STREAMLINED FEASIBILITY STUDY

Niagara County Refuse Site
Wheatfield, New York

RESPONSES TO USEPA COMMENTS RECEIVED JUNE 14, 1993
ON "STREAMLINED FEASIBILITY STUDY"
NIAGARA COUNTY REFUSE SITE
WHEATFIELD, NEW YORK, MAY 1993

figure 4.2
 TYPICAL SECTION RCRA LANDFILL CAP
 FEASIBILITY STUDY
 NIAGARA COUNTY REFUSE SITE
 Wheatfield, N. Y.

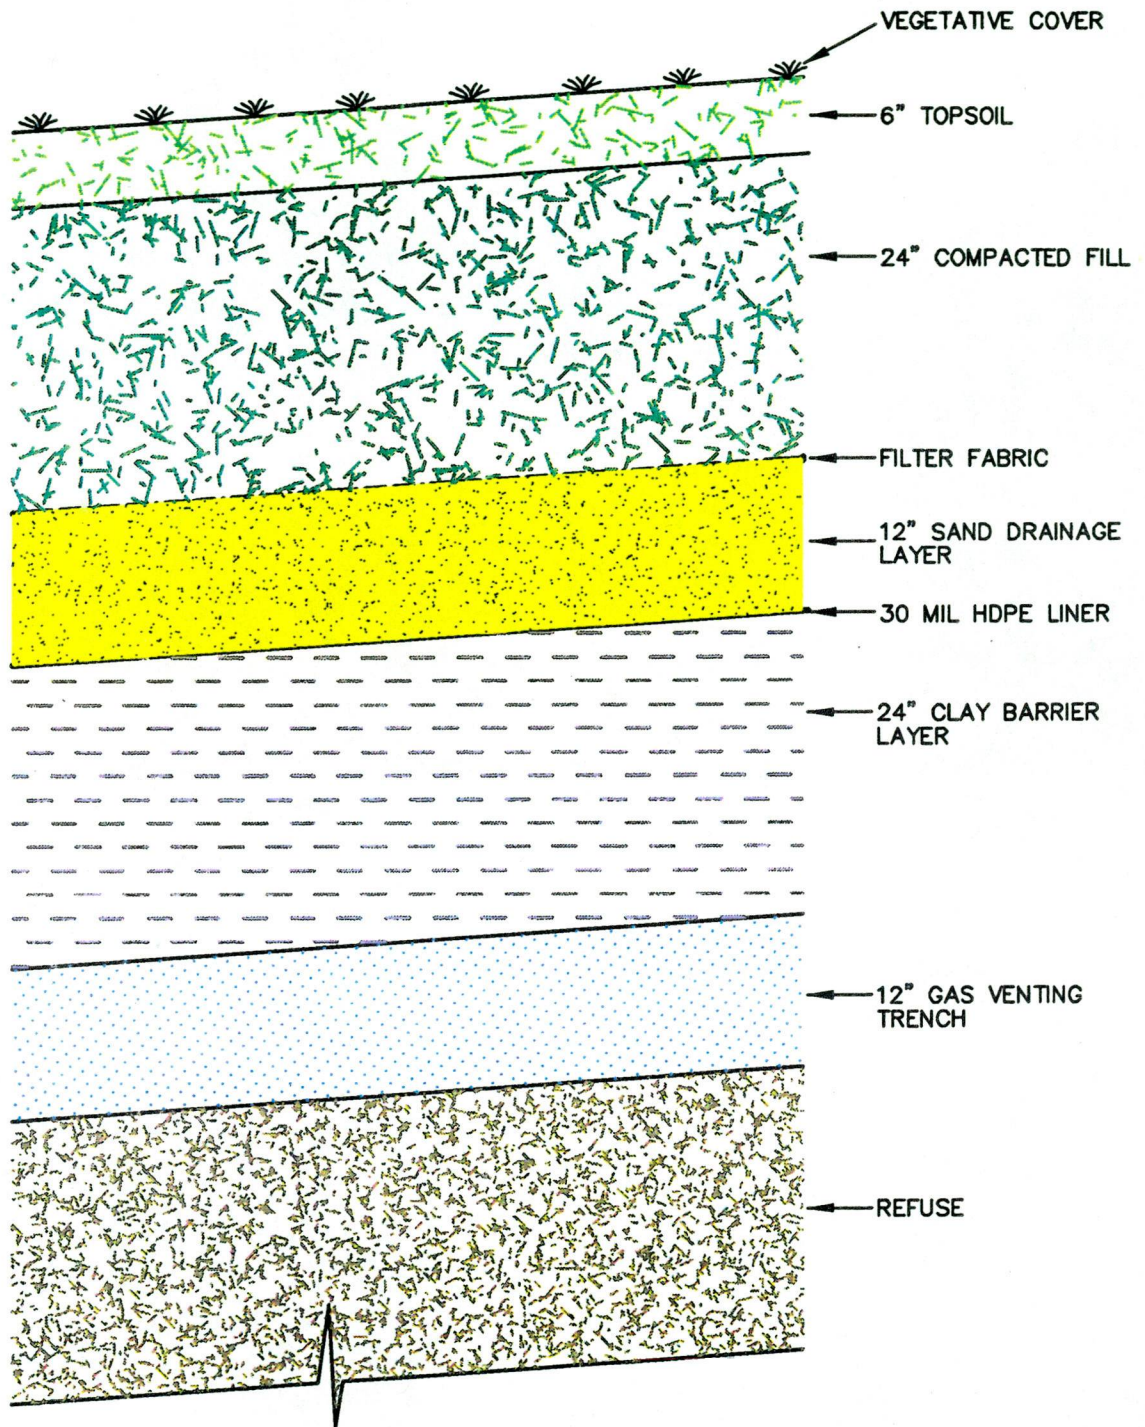
The RCRA standard cap presented by CRA is not consistent with the design presented in the CERCLA Municipal Landfill Guidance. In addition, the RCRA landfill cap design presented in Figure 4.2 of the FS appears to be inconsistent with the design presented on page 49 of the FS and that which is presented in the CERCLA Municipal Landfill Guidance. Please revise all references for consistency with the RCRA cap presented in the CERCLA Municipal Landfill Guidance and revise the specifications and associated cost estimates for this alternative accordingly.

The design presented in Figure 4.2 is consistent with that discussed above, with the exception of a 6-inch bedding layer between the 30-mil HDPE liner and the underlying 24-inches of clay. The figure has been revised to remove this bedding layer to maintain consistency with EPA guidance. The costs presented in the FS are based on the RCRA cap components discussed in Section 3.1.3, and do not include the 6-inch bedding layer. Therefore, the cost estimate for the RCRA cap does not require revision.

figure 4.1

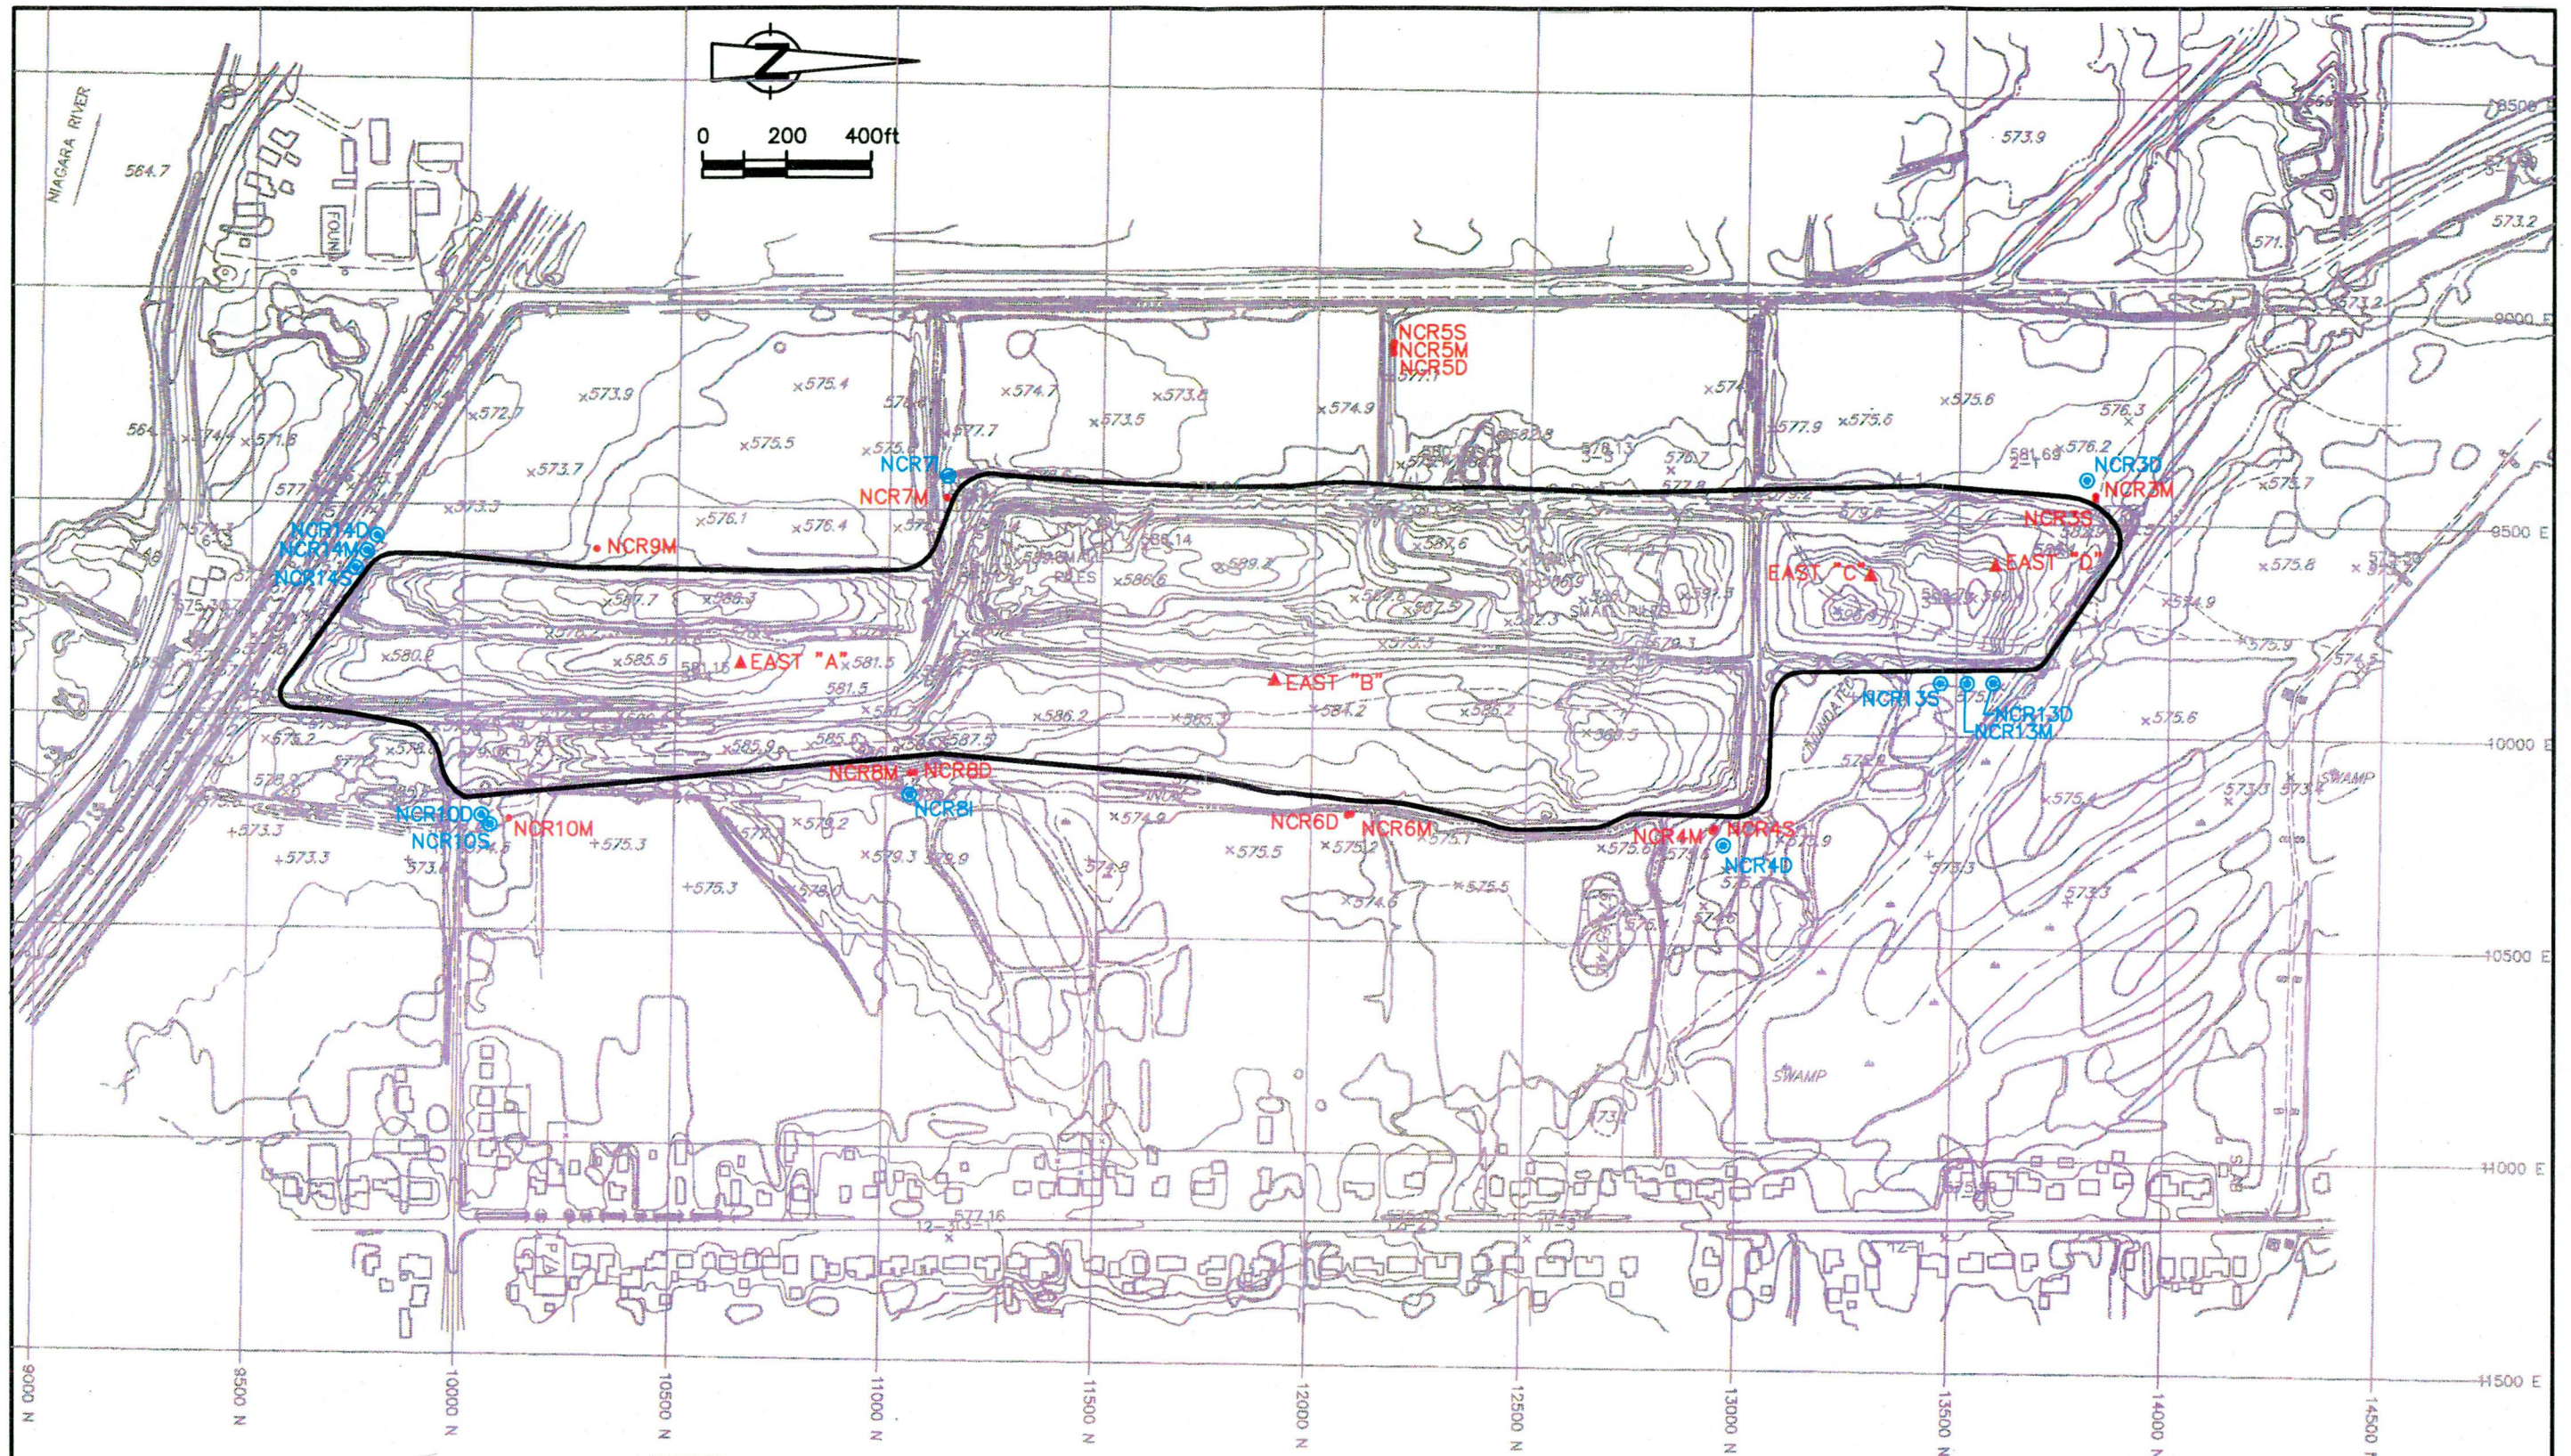
The proposed monitoring well program does not provide adequate coverage of all strata and areas. For example, groundwater flow in the lower till unit in the southern half of the Site is to the southwest. However, it is proposed that only one monitoring well (NCR-9M) in this area will be included in the monitoring program and this well is screened in bedrock. Therefore, monitoring of this well will not provide any data regarding contaminant presence/migration in the lower till unit in this area of the landfill. Modify the program for more complete coverage. Additionally, the label "Background Location" for monitoring wells NCR-1, 2, and 11 should be deleted as the background status of these wells has not been unequivocally demonstrated (see EPA's letter re Risk Assessment dated June 9, 1993).

The following groundwater monitoring wells have been added around the perimeter of the landfill: five bedrock wells, four lower till unit wells and three shallow (silt unit) wells. Section 4.3.1 and Figure 4.1 of the FS have been revised to include these proposed wells. Due to the addition of the new

monitoring wells around the perimeter of the landfill, existing monitoring wells at well nests NCR-1,2 and 11 and wells NCR-8M and -9M are not considered necessary. Well nests NCR-1, 2 and 11 are all located at least 500 feet away from the Site whereas the proposed wells are located immediately around the perimeter of the landfill and will provide early detection of any groundwater contaminants which may potentially migrate from the Site in the future. Therefore, the wells at well nests NCR-1, 2 and 11 have been deleted from Section 4.3.1 and from Figure 4.1. Wells NCR-8M and -9M are bedrock wells completed in the Vernon Formation. Due to the addition of five new bedrock wells to the monitoring well network, these two wells become redundant and are not proposed to be sampled. They will, however, be maintained for hydraulic monitoring. As summarized in Section 4.3.1 of the FS, the proposed monitoring well network will now consist of six shallow silt unit wells, nine lower till unit wells and nine bedrock wells for a total of 24 monitoring wells.
